14 August 2020

## **RE: AMENDMENT OF ALBANY WIND FARM APPLICATION – AVIFAUNAL**

Figure 3. The two turbine layouts together.

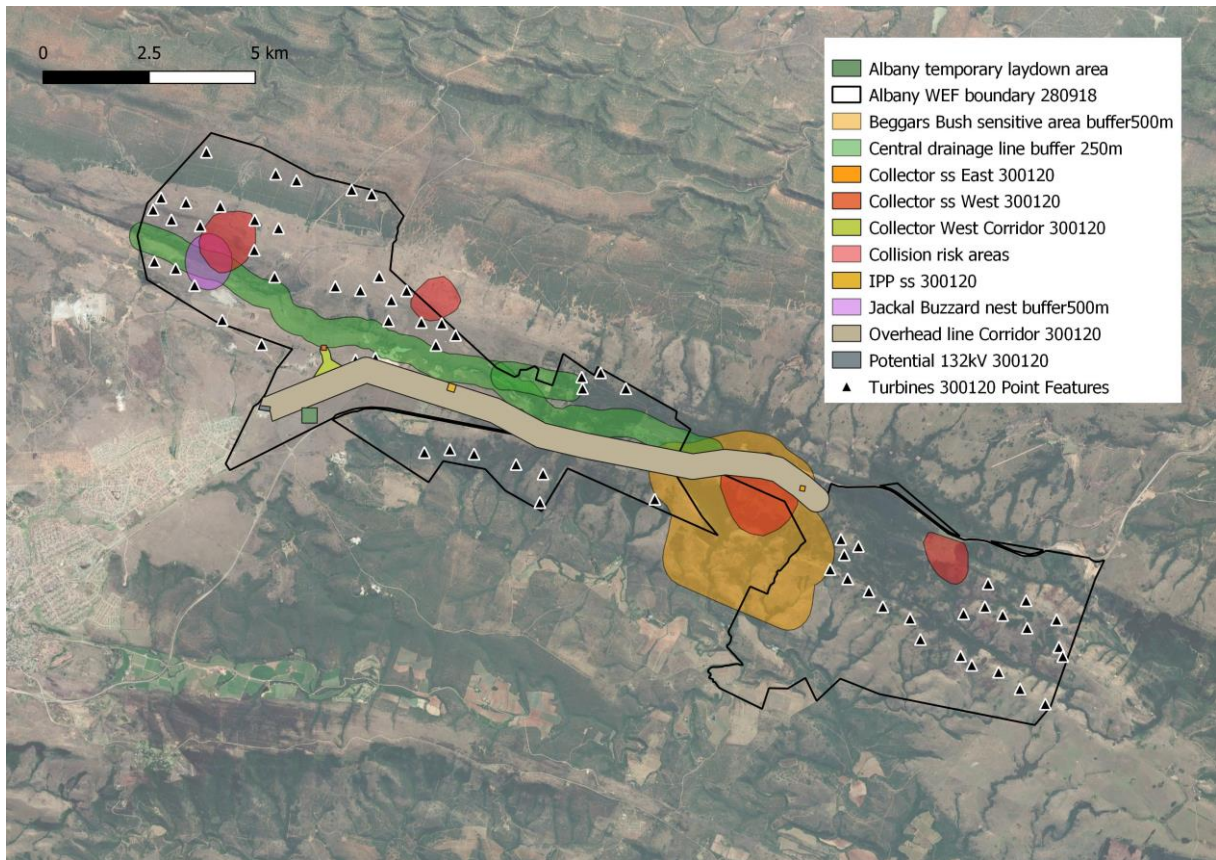
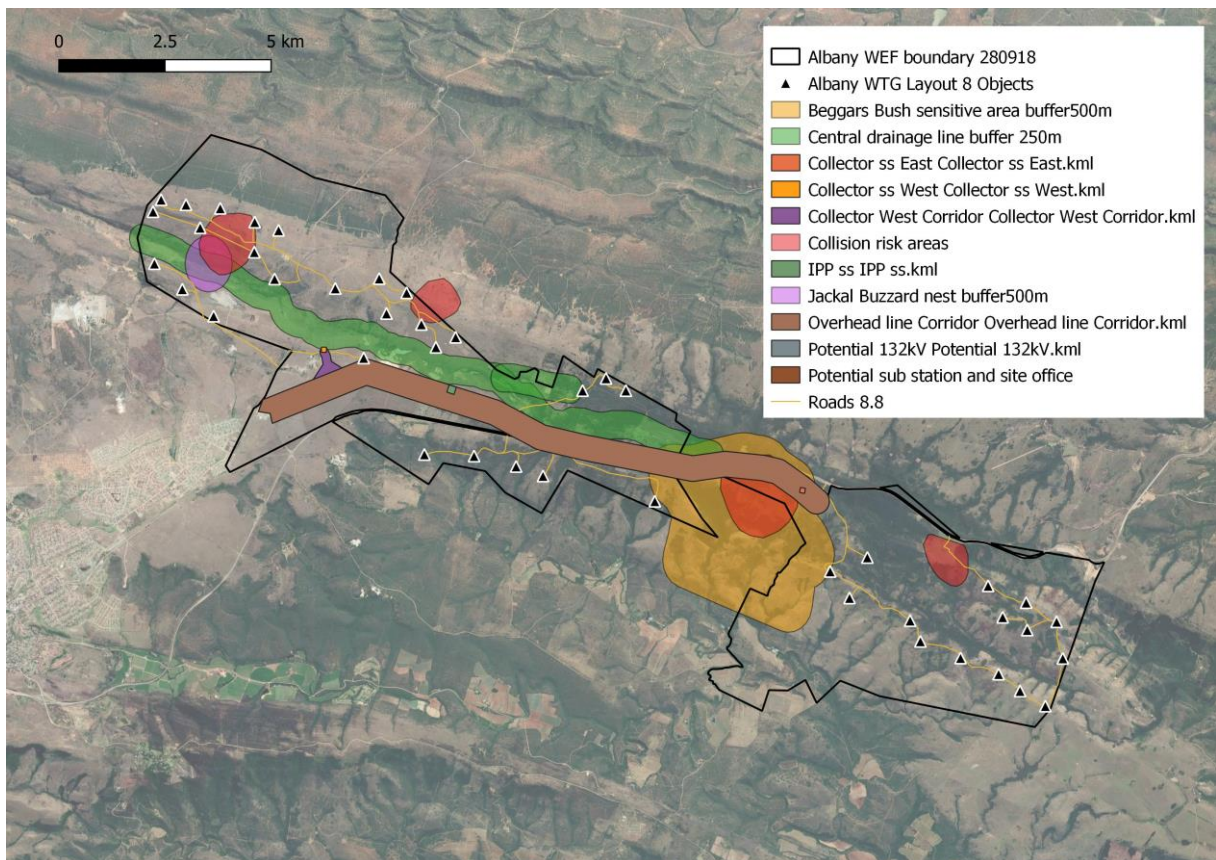
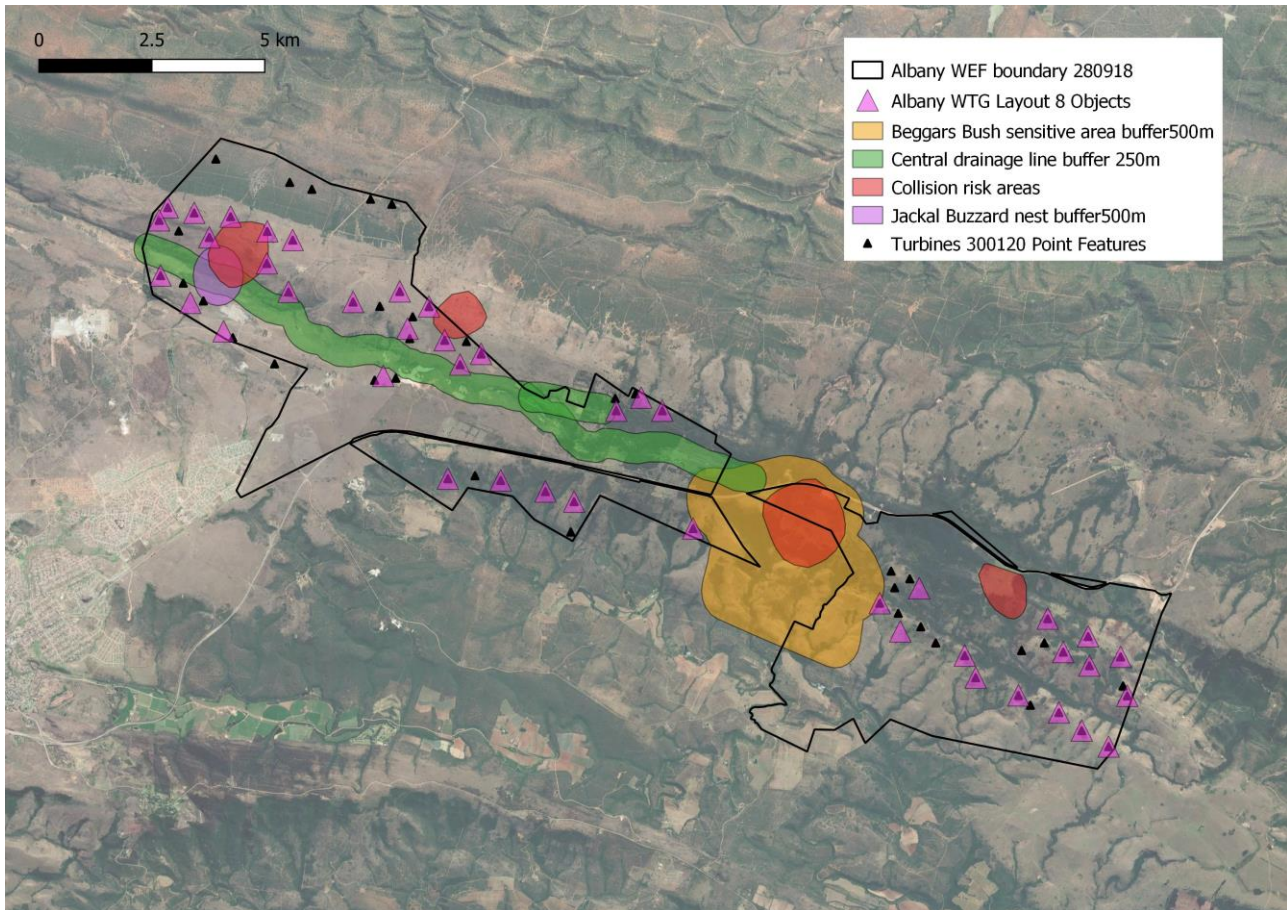
Due to the reduction from 66 to 43 turbines a change in the layout of the facility is necessary. Figure 1 shows the original layout and Figure 2 shows the new layout. The new proposed layout avoids all avifaunal sensitive areas identified previously.

Figure 3 shows turbines only (both original & current proposed) in order to more clearly demonstrate the difference between the original 66 turbine layout and the new 43 turbine layout. Pink icons show the new proposed positions and black icons show the original positions. It is clear that a number of turbines in the far north-west have been dropped, as well as in the centre of the site. A number of turbines have also moved slightly. A summary of the changes is presented in Appendix 1.
